United States Patent and Trademark Office

APPLICATION NO.	FILING DATE	FIRST NAMED INVENTOR	ATTORNEY DOCKET NO.	CONFIRMATION NO.
09/886,741	06/21/2001	Vincent Chan	ATI.0100680	6028
759	90 06/18/2004	EXAMINER		
Christopher J. 1	Reckamp, Esq.	CHU, CHRIS C		
VEDDER, PRIC	CE, KAUFMAN & KA	MMHOLZ		
222 North LaSal	lle Street	ART UNIT	PAPER NUMBER	
Chicago, IL 60	0601	2815

DETAILED ACTION

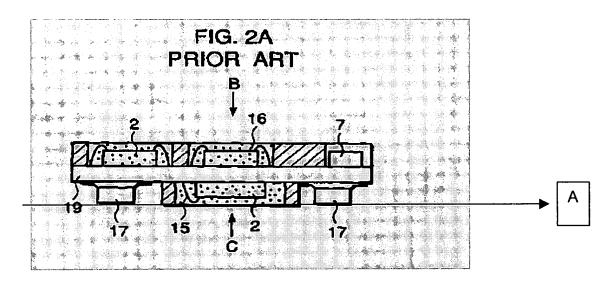
Regarding claim 59, Tanioka discloses in Figs. 2A - 2C a multi-die module, comprising:

- a substrate (19) having a first surface;
- an unpackaged semiconductor die (2) mounted to the first surface of the substrate, the semiconductor die encapsulated (16) in a structure; and
- a packaged semiconductor die (17) mounted on the first surface of the substrate.

Tanioka does not disclose the encapsulating structure being further comprised of an encapsulating material of a metal cap. However, Distefano discloses in Fig. 2 and column 4, line 21 - 33 an encapsulating structure being further comprised of an encapsulating material of a metal cap (20). Thus, it would have been obvious to one of ordinary skill in the art at the time when the invention was made to modify Tanioka by using the metal cap as taught by Distefano.

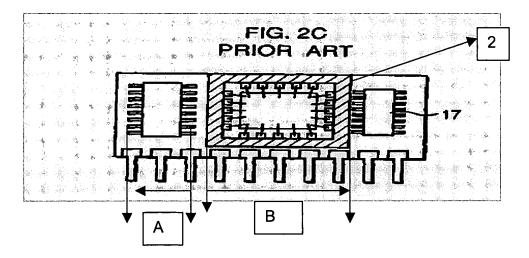
Even further, applicant argues "applicants submit that nowhere in the Office Action does the Examiner specifically point out where the references recites the claim limitation 'wherein the planar top surface of the encapsulated structure and the top surface of the packaged semiconductor die are of equal distance from the substrate.' ... Applicant submit[s] that Tanioka does not disclose Applicants' claimed subject matter." This argument is not persuasive. Tanioka clearly shows in Fig. 2A the planar top surface of the encapsulated structure (2) and the top surface of the packaged semiconductor die (17) are of equal distance from the substrate (look at the line A in Fig. 2A).

Next, applicant argues "Tanioka does not disclose, teach or suggest, claim 57's language including, inter alia, '... a ... graphics-processing die encapsulated on the package module in a structure having a planar top surface; and a packaged memory die having a top surface and attached to the package module; wherein the planar top surface of the encapsulated structure and the top surface of the packaged memory die are of equal distance from the substrate,' nor does Tanioka disclose, teach or suggest the subject matter of claim 57 as a whole." This argument is not persuasive. Tanioka clearly shows in Fig. 2A the planar top surface of the encapsulated structure (2) and the top surface of the packaged semiconductor die (17) are of equal distance from the substrate (look at the line A in Fig. 2A).

Next, applicant argues "Tanioka does not disclose, teach or suggest, claim 58's language including, inter alia, '... an unpackaged semiconductor die ... encapsulated in a structure having a planar top surface; and a packaged semiconductor die having a top surface and mounted on the first surface of the substrate; wherein the planar top surface of the encapsulated structure and the top surface of the packaged memory die are of equal distance from the substrate,' nor does Tanioka disclose, teach or suggest the subject matter of claim 58 as a whole." This argument is not persuasive. Tanioka clearly shows in Fig. 2A the planar top surface of the an unpackaged semiconductor die (2) ... encapsulated in a structure having a planar top surface; and a packaged semiconductor die (17) having a top surface and mounted on the first surface of the substrate (19); wherein the planar top surface of the encapsulated structure and the top surface of the packaged memory die are of equal distance from the substrate (look at the line A in the previous page).
